SUPPLIER DOCUMENT COVER SHEET**Syncrude Canada Ltd.****WorleyParsons**
resources & energy**Worley – Syncrude Projects Group**

Supplier Name:	PENTICTON FOUNDRY LTD.
Client Contract No.:	4410322556
Purchase Order Description:	HCWI Spools
Supplier Document Title:	Preliminary Detailed Fabrication Drawings and Bill of Materials

SUPPLIER DOCUMENT TITLE: Preliminary Detailed Fabrication Drawings and Bill of Materials**VENDOR DOCUMENT REVIEW**

A1-19027-100-00 Spool RD-51-L-585-1 sketch
ESTIMATED WEIGHT: 24,865 lbs. (11,275 kg.)

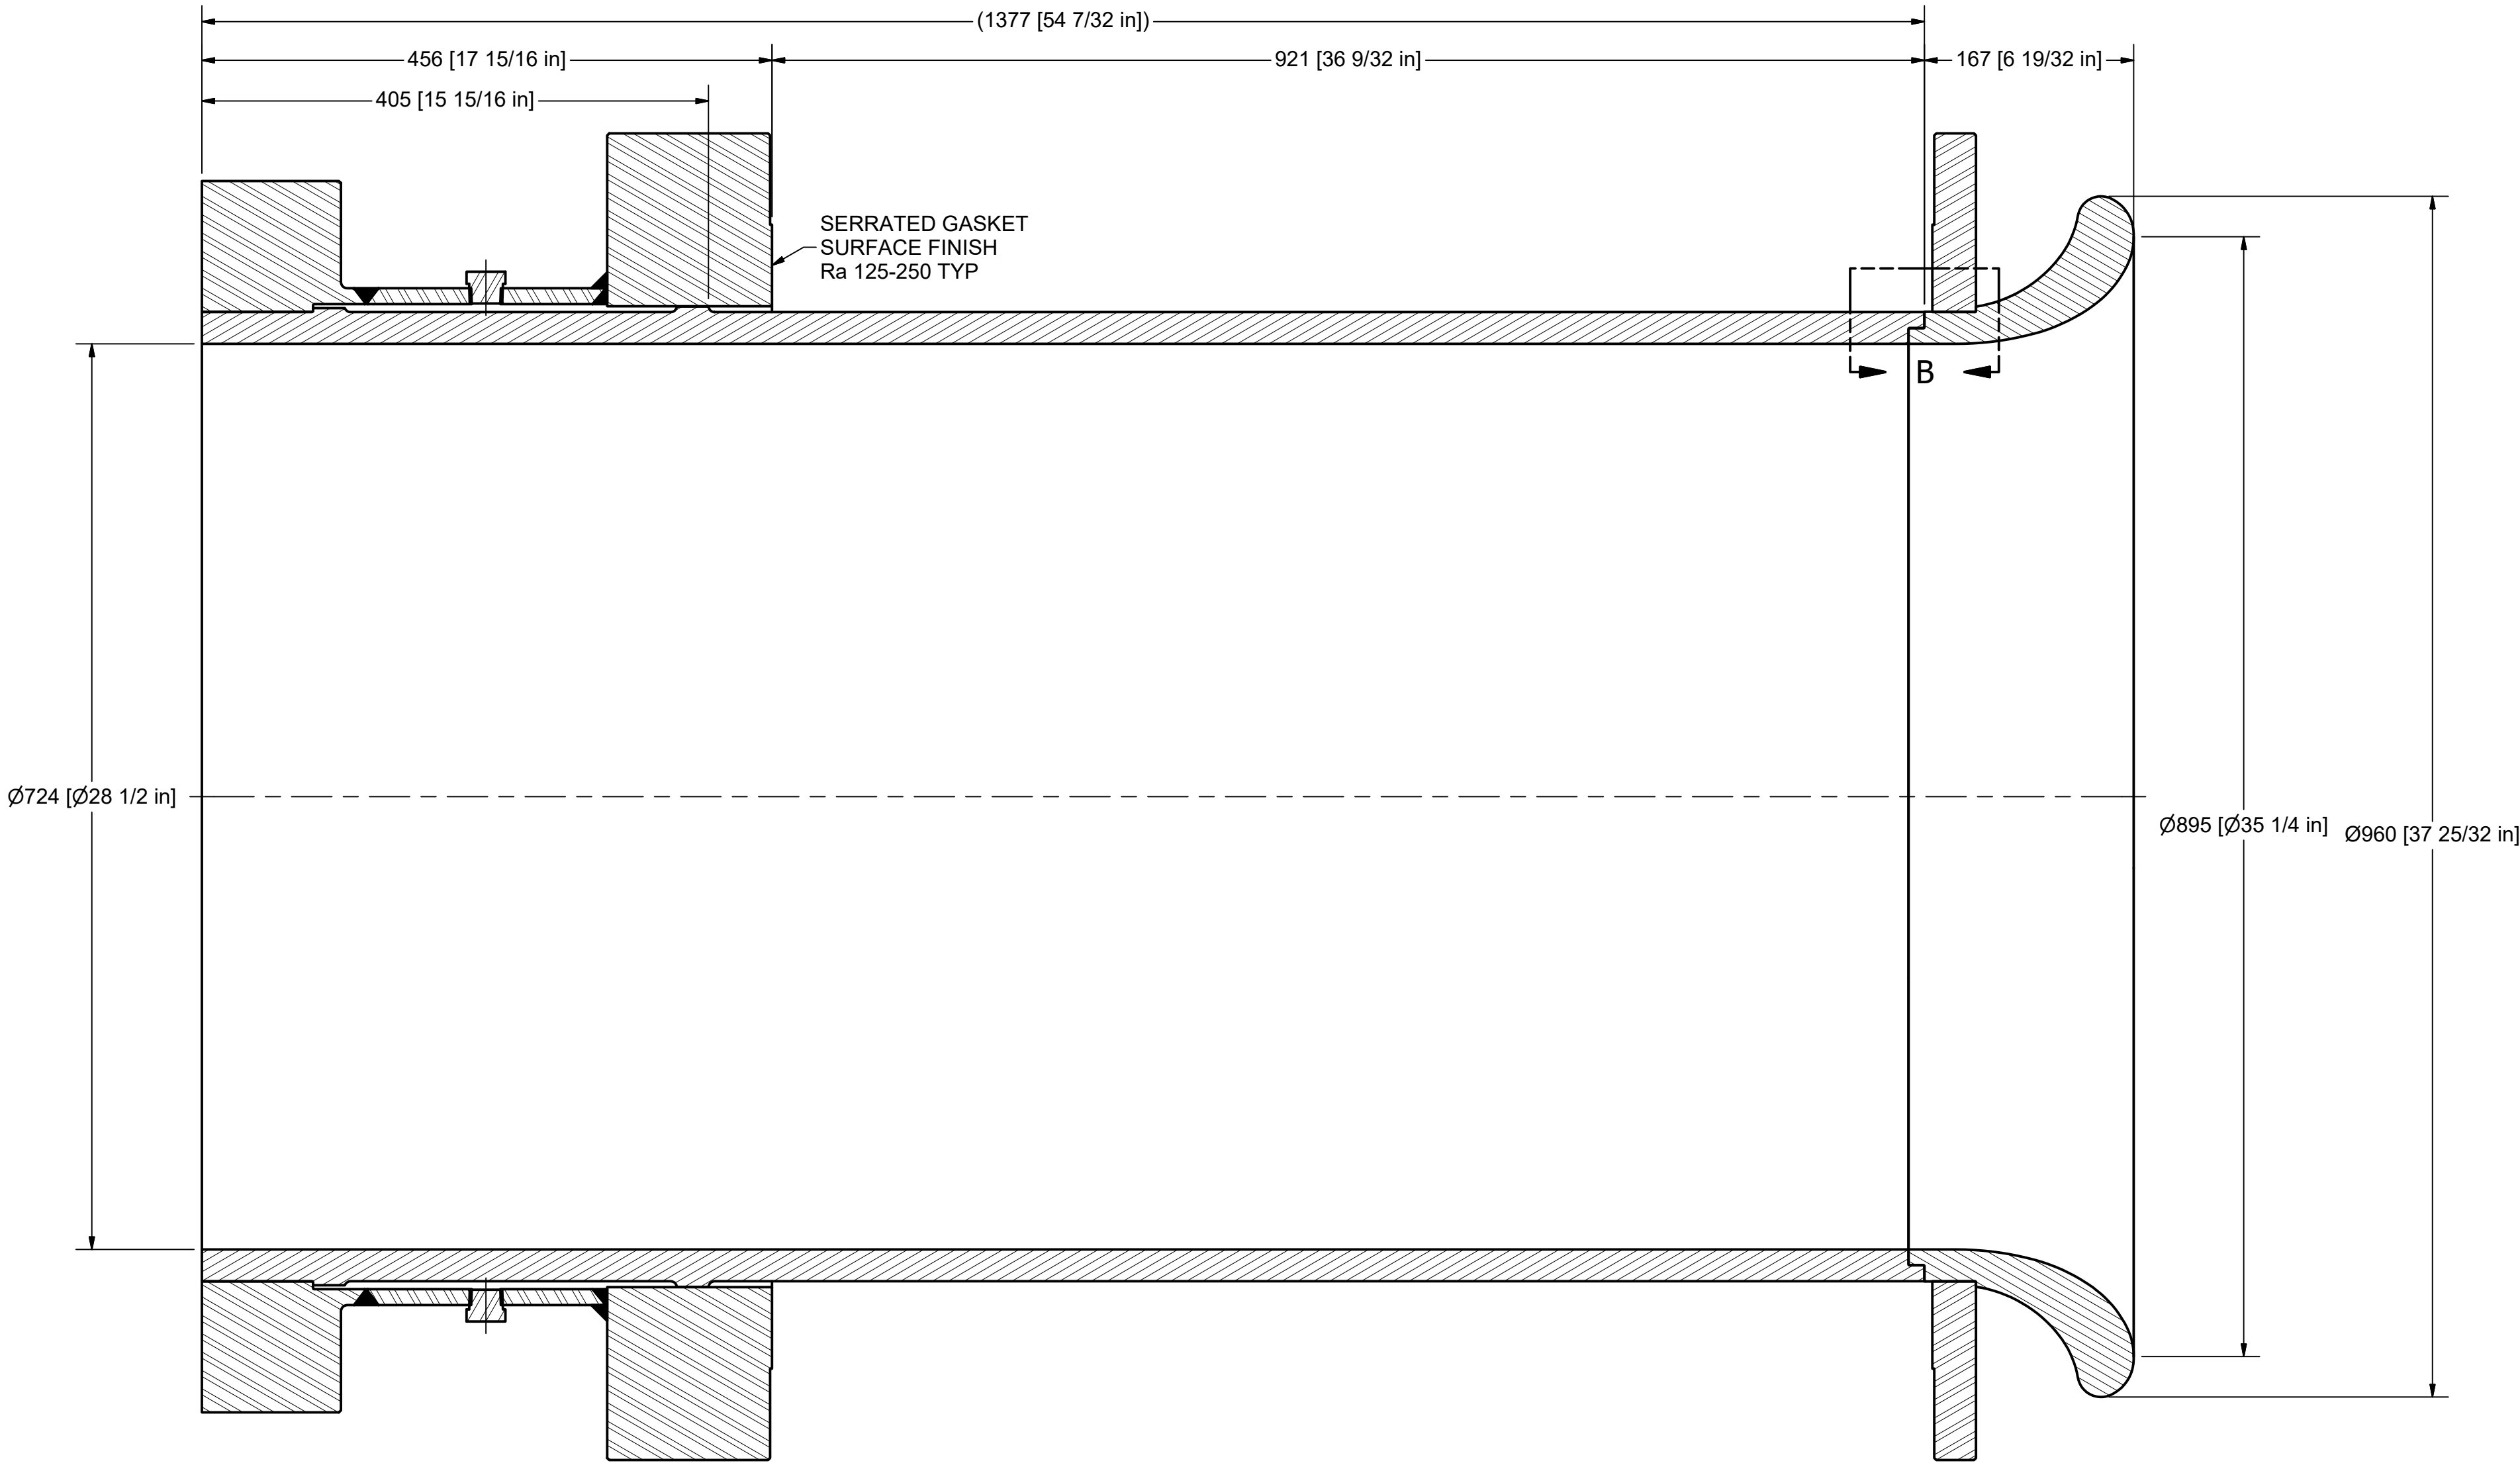
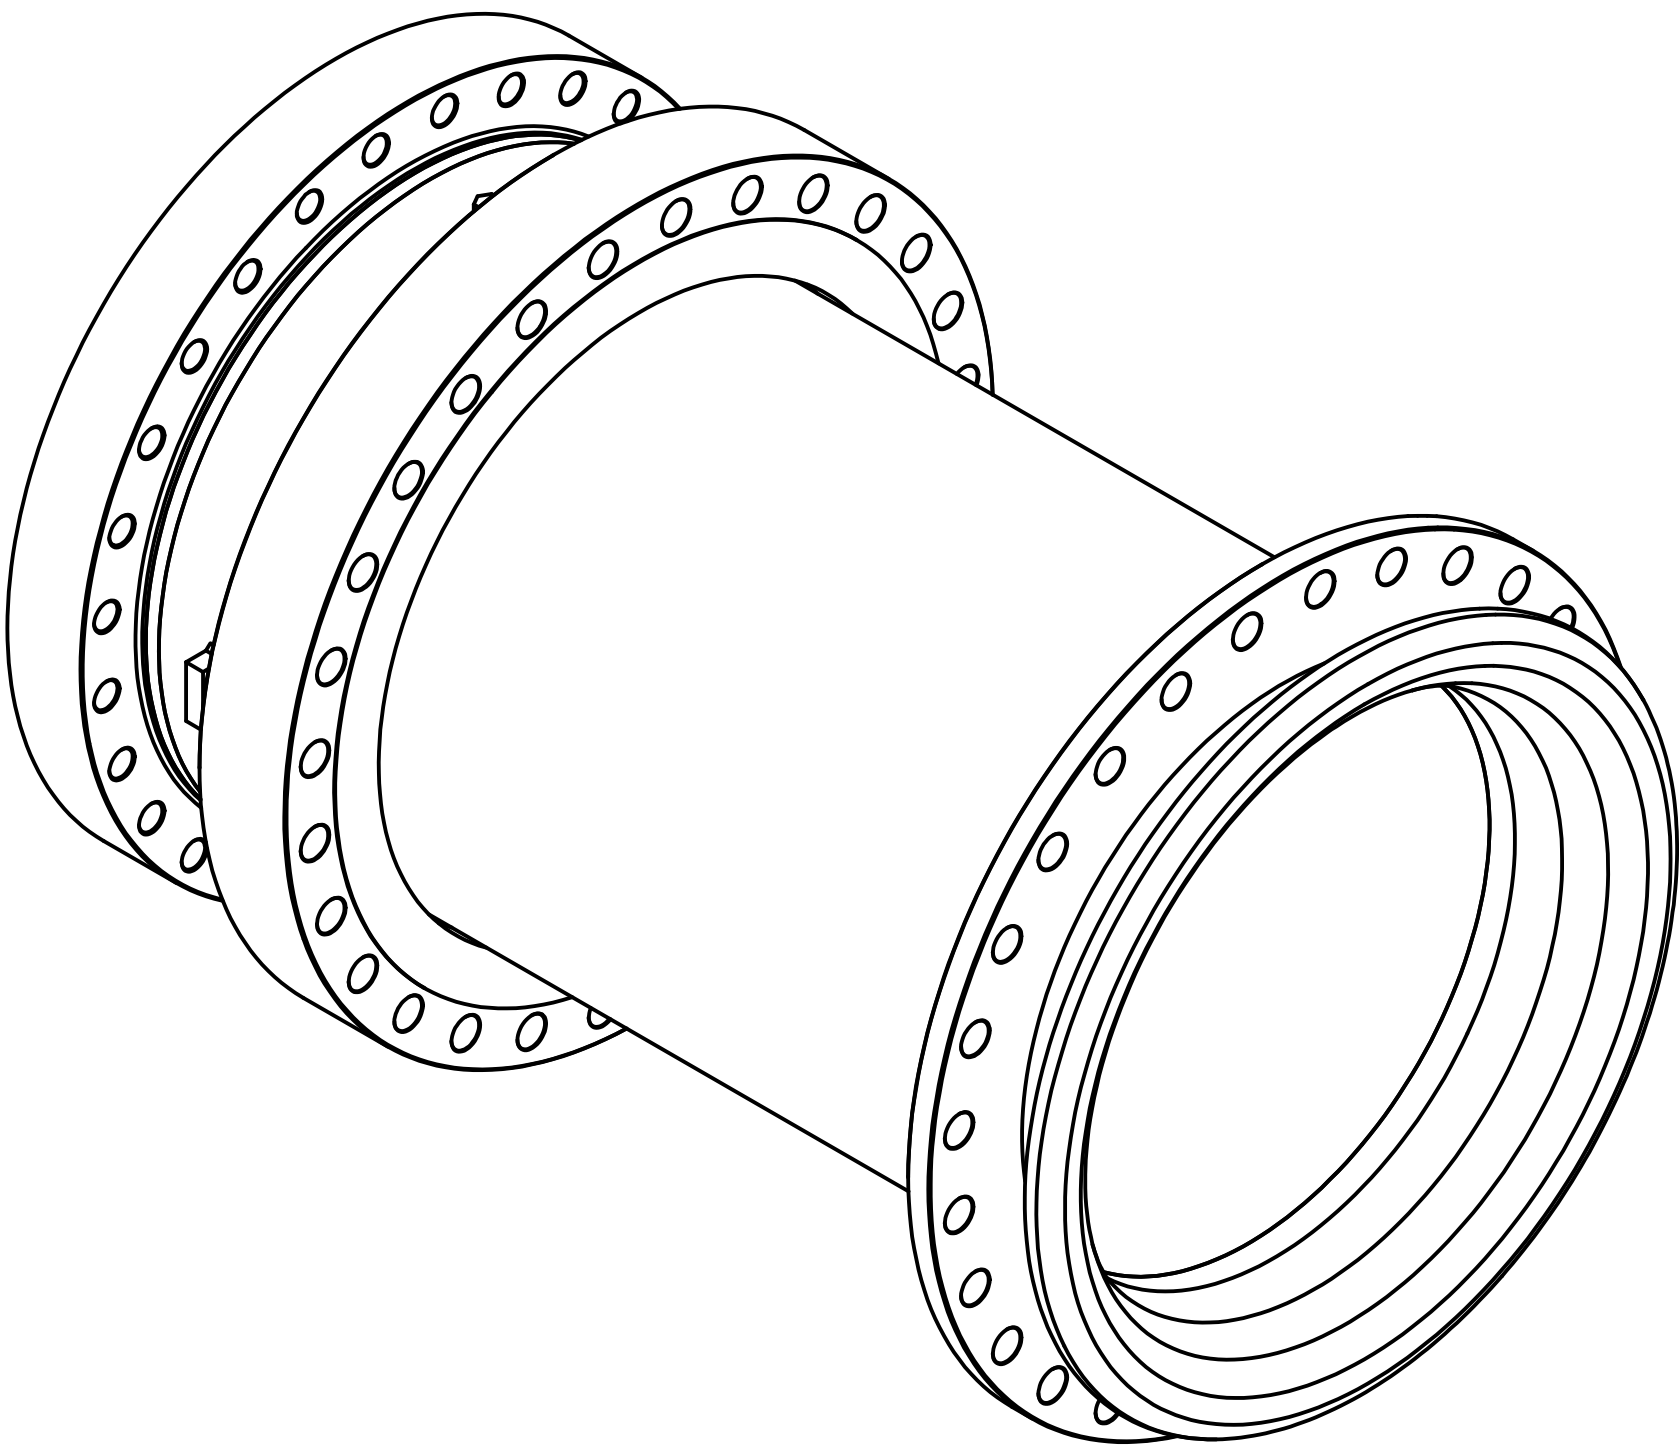
Refer to comments on individual spool sketches
